C2PC Request Letter

Class II permissive change for **FCC ID: 2AXJ4XE75V2**

Applicant: TP-Link Technologies Co., Ltd.

Add “Deco XE75 Pro” in model names, the difference with previous models “Deco XE75,

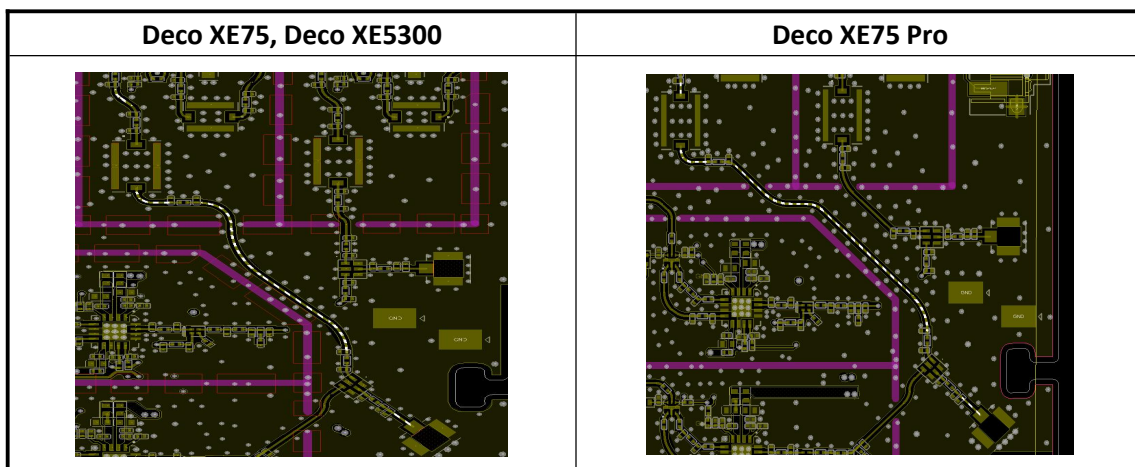
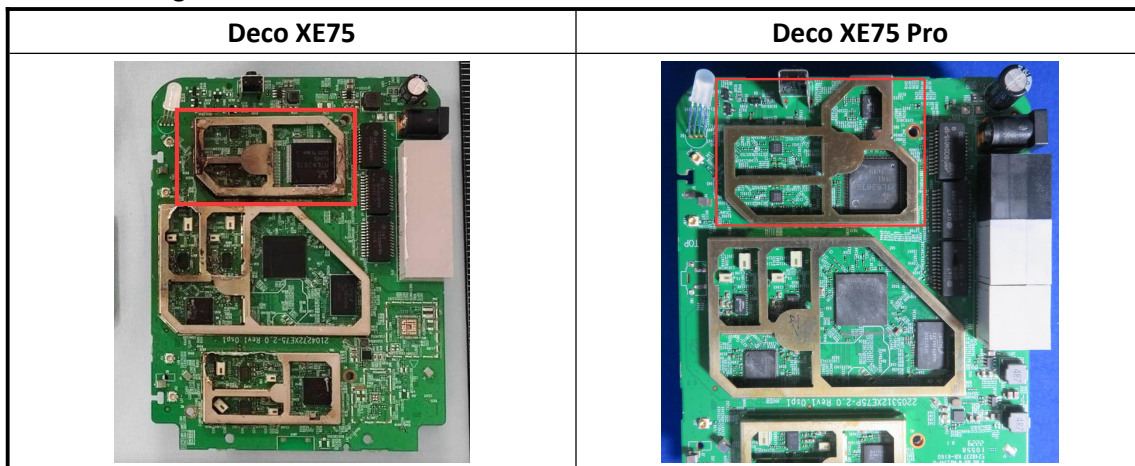
Deco XE5300” as follows:

1. Ethernet chip is changed.
2. The color and size of RJ45 connector is different.
3. Wi-Fi 5G RF trace is moved.

4. Shielding case of Wi-Fi 2G is different.
